Report Committee of Adjustment

File: A-2023-0161

Address: 1 Stillman Drive

Appendix B – Revised Site Plan

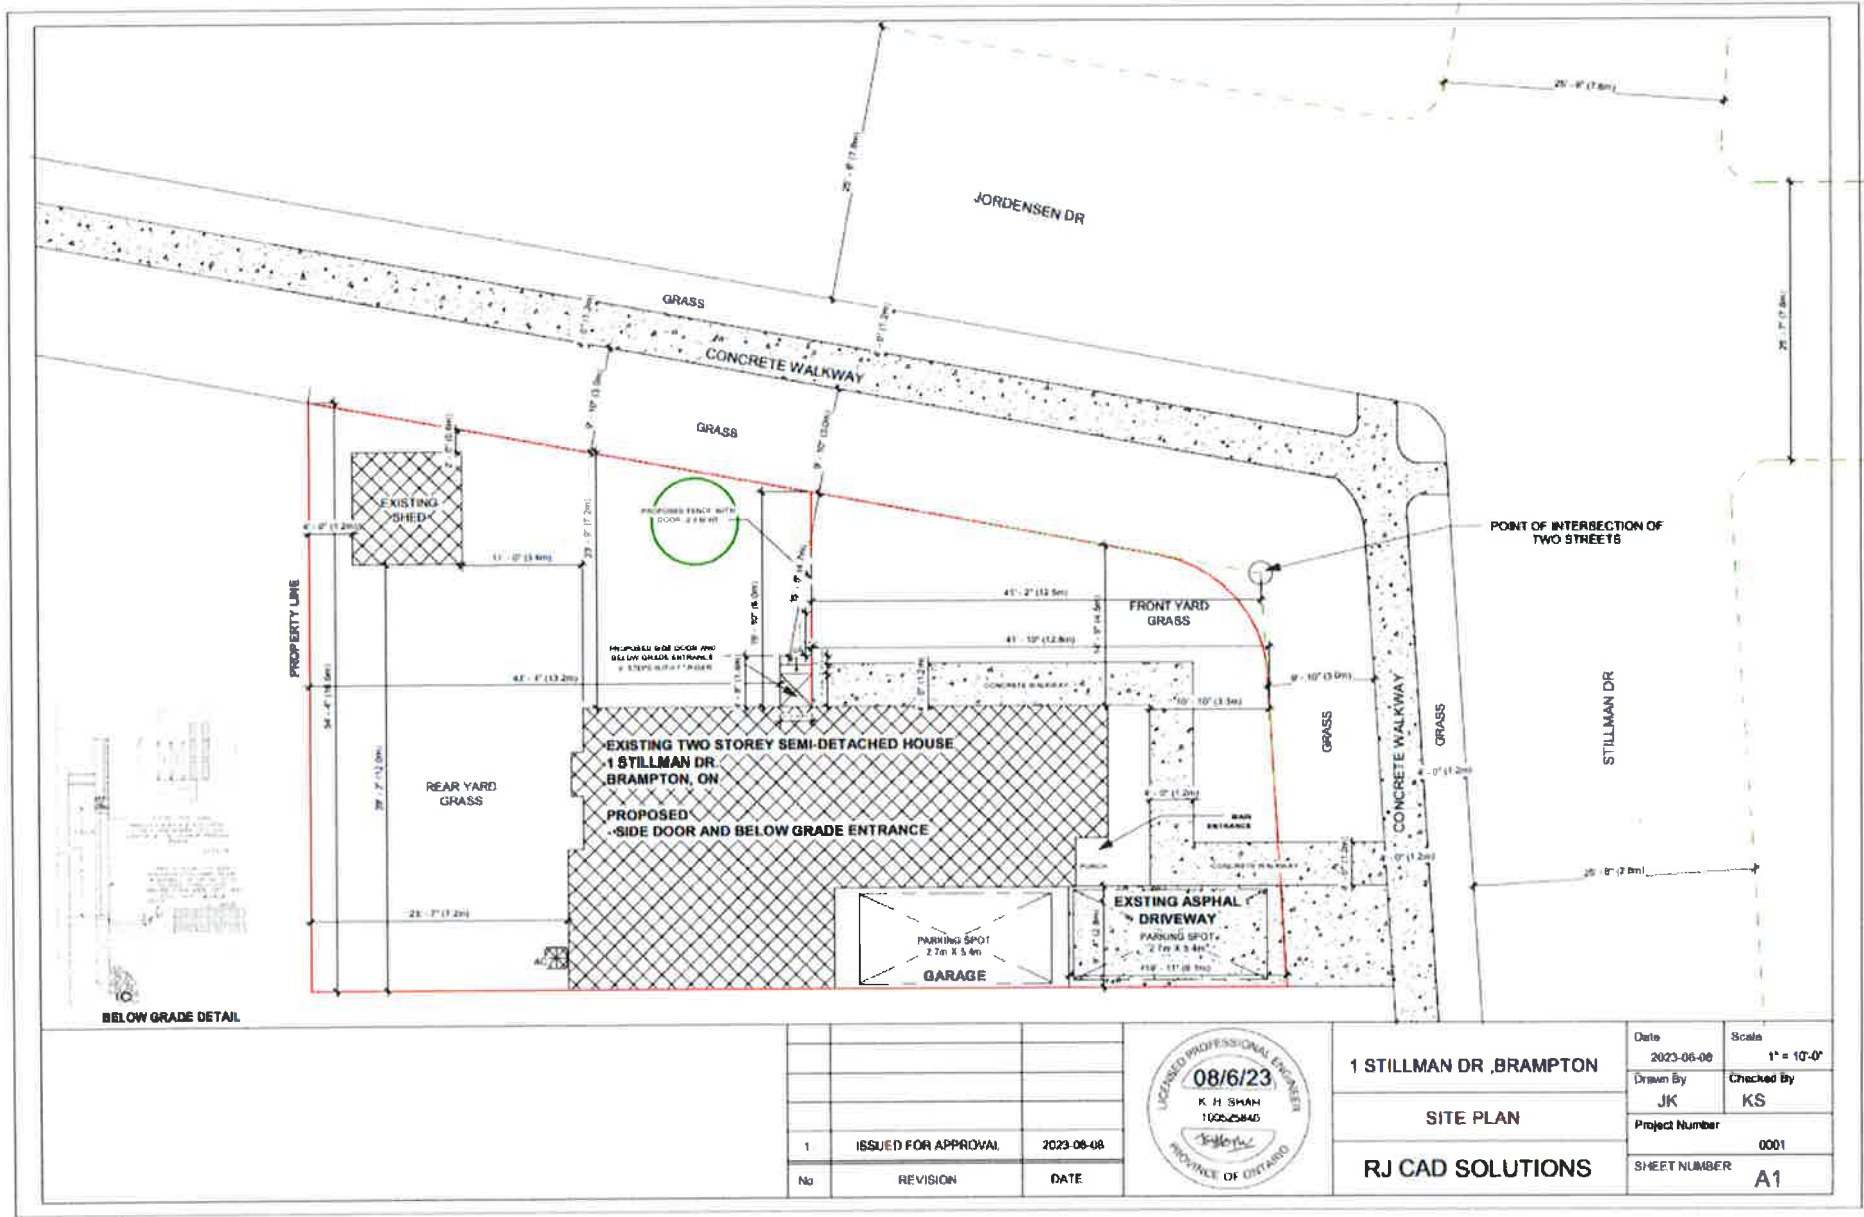
The proposed below grade entrance will be constructed along the western wall of the dwelling located on a corner lot. The below grade entrance will be accessed by two steps leading to a side door. The applicant has revised their drawing to extend the existing fencing to provide screening (see Appendix B). As a result, the below grade entrance is not considered to negatively impact the overall streetscape as it will be screened from the streetscape by the fence and not be visible. A condition of approval is recommended that the fence used to screen the below grade entrance shall be maintained, and shall not be removed or lowered, but may be repaired or replaced when necessary. Additionally, the below grade entrance shall not be used to access an unregistered second unit.

Variance 1 is requested to permit a below grade entrance between the main wall of the dwelling and flankage lot line on a corner lot. The location of the below grade entrance is adequately fenced and screened to the satisfaction of the Planning Department. Subject to the recommended conditions of approval, the variance is considered desirable and appropriate for the development of the land as it is not anticipated to generate negative impacts to the streetscape.

1. That the extent of the variances be limited to that shown on the sketch attached to the Notice of Decision;
 2. Staff recommend that approval be based on the revised site plan provided by the applicant (Appendix B) showcasing the fence screening the below grade entrance;
 3. That the below grade entrance shall not be used to access an unregistered second unit;
 4. That the proposed fence used to screen the future below grade entrance shall be maintained, and shall not be removed or lowered, but may be repaired or replaced when necessary;
 5. That failure to comply with and maintain the conditions of the Committee shall render the approval null and void.
-
